**Boston Edison**

May 30, 1996  
BECo Ltr. #96-054

Boston Edison Company Response to NRC Questions on Residual Heat Removal and Fuel Pool Cooling Intertie Piping (TAC. NO. M91524)

### Revised Relief Request: Relief from ASME, Section XI In-service Inspection Requirements Pursuant to 10 CFR 50.55a(a)(3)

FIGURE 1

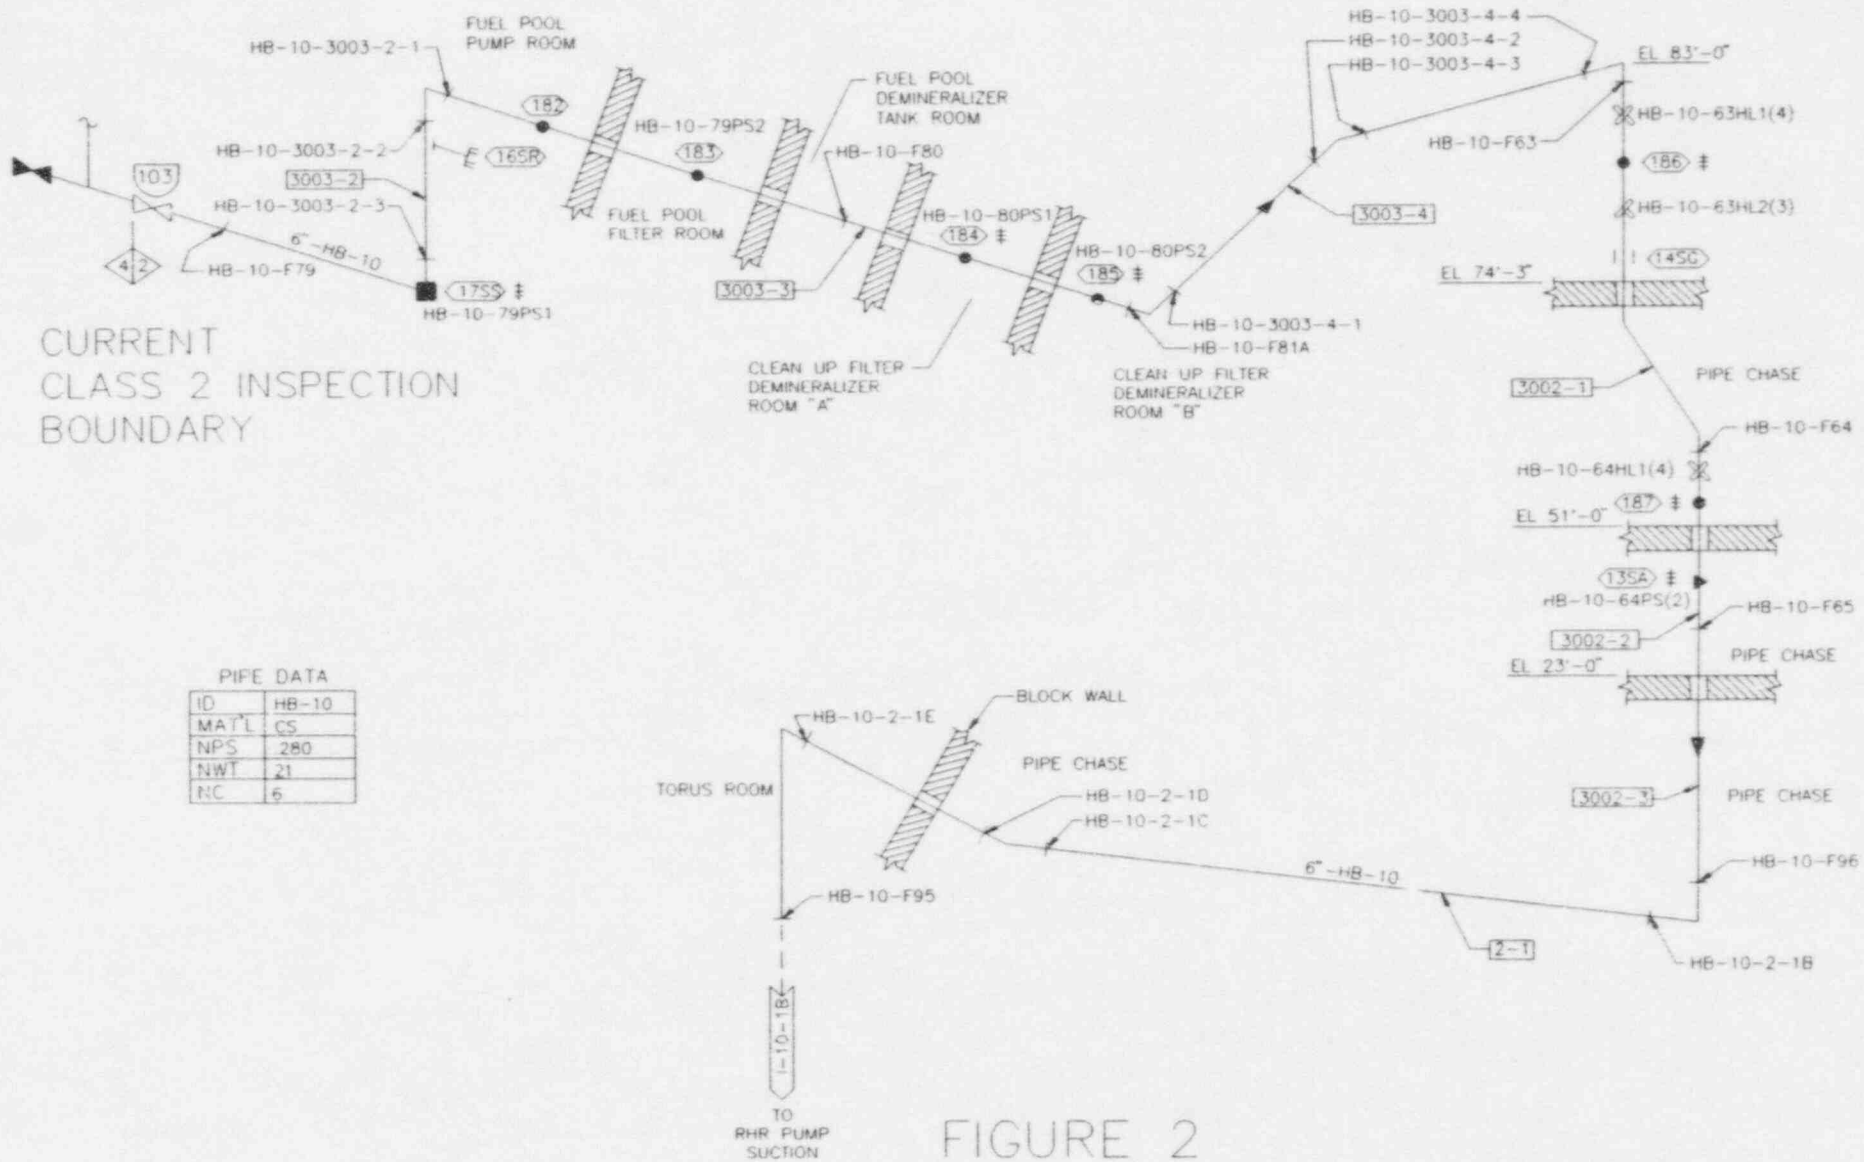
The RHR/FPC intertie piping welds and supports within the second ten-year ISI interval scope and ASME Code examination requirements are shown in Attachment #1. The intertie piping is ASME Code Class 2 category up to valve 1001-103 and passes through high radiation areas. The section of intertie piping in question (i.e., between the RHR suction line and valve 103) is shown functionally on Figure 1. Figure 2 represents an expanded isometric view of this section of piping. The horizontal portion of the piping above the 74'-3" elevation is located within high radiation areas.

System Considerations: The RHR/FPC intertie is branched from the shutdown cooling line that provides suction to the RHR pumps. This portion of the line is normally isolated during power operation. A manual isolation valve, 1001-103, in the intertie line separates the ASME Class 2 RHR piping from the non-code FFC piping.

Pilgrim's Third Ten-Year ISI Program includes a sample of RHR/FPC intertie hangers and welds in full compliance with the revised code selection criteria and NRC guidance. Weld HB-10-F79, and hangers H-10-1-17SS and H-10-1-182 are scheduled to be examined during RFO#11. Weld HB-10-3003-2-2 is scheduled for examination in the third period of the current third ten-year ISI interval. These welds will be volumetrically examined following the examination requirements and acceptance standard of Examination Category C-F-2, Item No. C5.60 of ASME Section XI, 1989 Edition. This code does not require examination of these welds, since the intertie piping is 6-inch schedule 40 with less than 3/8-inch wall thickness. However, the planned examinations are intended to comply with the NRC guidance to perform augmented examinations of certain thin-wall piping excluded by the code. In addition, ASME Section XI VT-2 leak test of the intertie piping up to the 103 valve is scheduled during RFO#11. Thus, compliance with the NRC guidance will be achieved during the third ten-year ISI interval, and the inspections should reinforce the bases for granting the requested relief with no conditions.
